# Service Bulletin

Bulletin No.: PI0421C

**Subject:** Fluid Leak after Clutch Actuator Replacement

**Models:** 2011-2013 Chevrolet Cruze  
2012-2013 Chevrolet Sonic  
Equipped with Manual Transmission

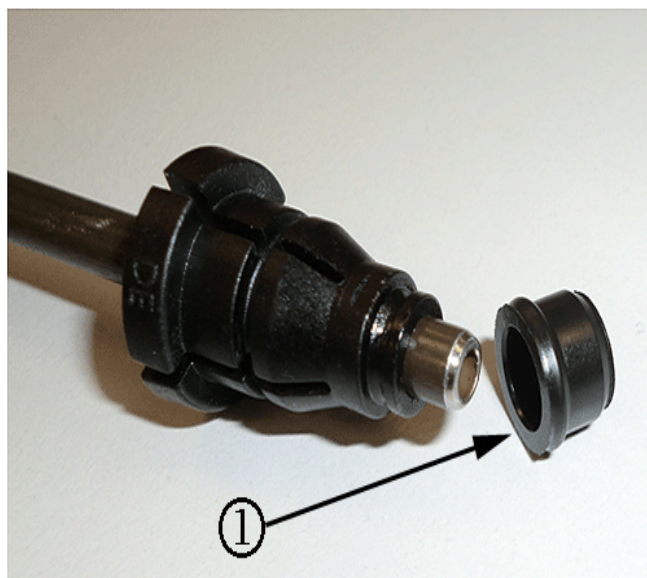
Technicians may also notice the clutch pedal is hard to bleed or clutch slave cylinder seal fails after 3-4 clutch pedal pumps and a fluid leak is observed from the clutch actuator cylinder pipe elbow after the clutch actuator cylinder replacement. The condition may be present as soon as the repair is completed or may surface within 1,600 km (1,000 mi) of repair. The vehicle may also have a repeat clutch performance concern such as slip or high shift effort and clash.

Further inspection may reveal that the leak is brake fluid coming from the clutch actuator cylinder pipe elbow.

After replacement of the clutch actuator cylinder, the seal from the clutch actuator cylinder pipe may be retained in the pipe elbow. The new clutch actuator cylinder has a new seal attached to the pipe and if the old seal is not removed, it can cause a poor seal allowing fluid to leak. It can also cause a blockage in the pipe restricting flow into or out of the clutch actuator cylinder. If the seal is in the right position, fluid will enter the clutch actuator cylinder but does not exhaust and after 3-4 clutch cycles, the cylinder over strokes and the seal fails. The seal can also block the line where the clutch cylinder will not stroke and the pedal will feel hard.

Remove the old seal from the clutch actuator cylinder elbow pipe following the procedure below.

1. Raise the vehicle.
2. Disconnect the clutch actuator cylinder elbow pipe and remove the old seal (1).
3. Connect the clutch actuator cylinder elbow pipe. Make sure there is only one seal in place.
4. Lower the vehicle.
